**Re: 2<sup>nd</sup> Technical Submission Review – Lona / Forum Vista Creek – Master Plan, Site Plan and Final Plat**  
Application Number: **DA-2248-01**  
Case Numbers: **2021-7009-00; 2021-4025-00; 2021-3051-00**

2<sup>nd</sup> Technical Submission Review Comments

# VISTA CREEK SUBDIVISION FILING NO. 1

## VICINITY MAP (N.T.S.)

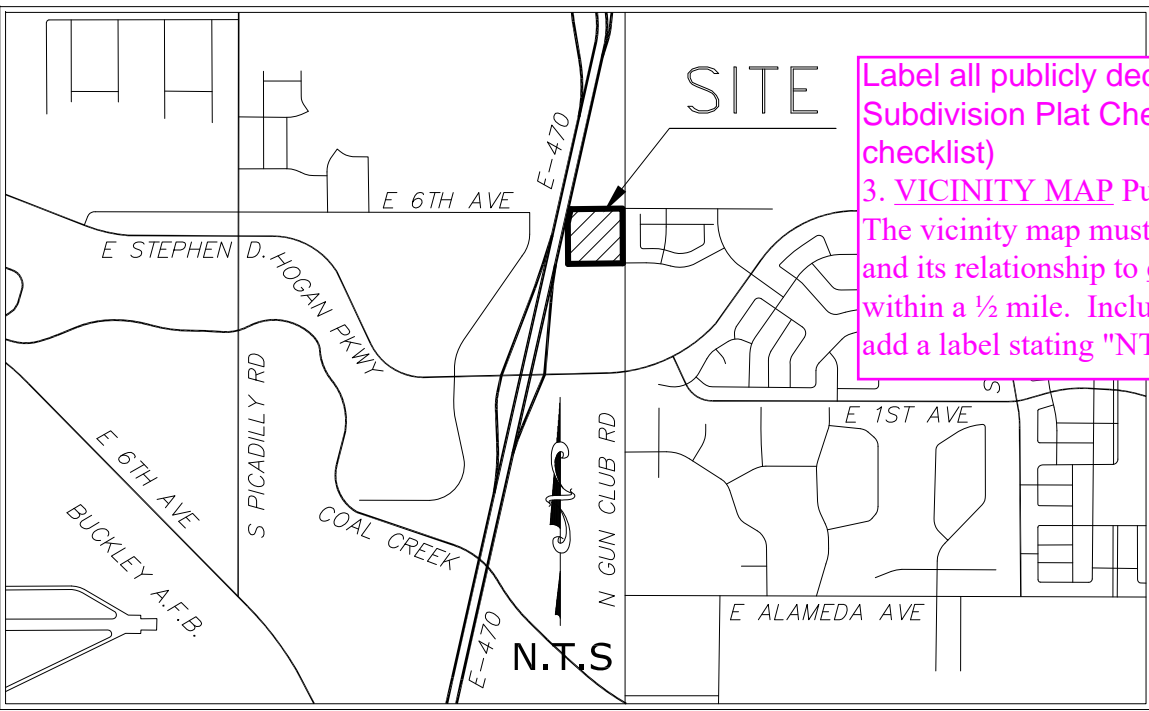
Label all publicly dedicated roads within 1/2 mile of the site per COA Subdivision Plat Checklist (Typical). Per COA 2022 Subdivision Plat checklist)  
3. VICINITY MAP Put on Sheet 1.  
The vicinity map must show the outline of the property being subdivided and its relationship to existing street rights-of-way (with street name labels) within a ½ mile. Include a north arrow and distance ratio. If not to scale, add a label stating "NTS".

ALTURA RESPONSE:  
ADDED ADDITIONAL STREET NAMES
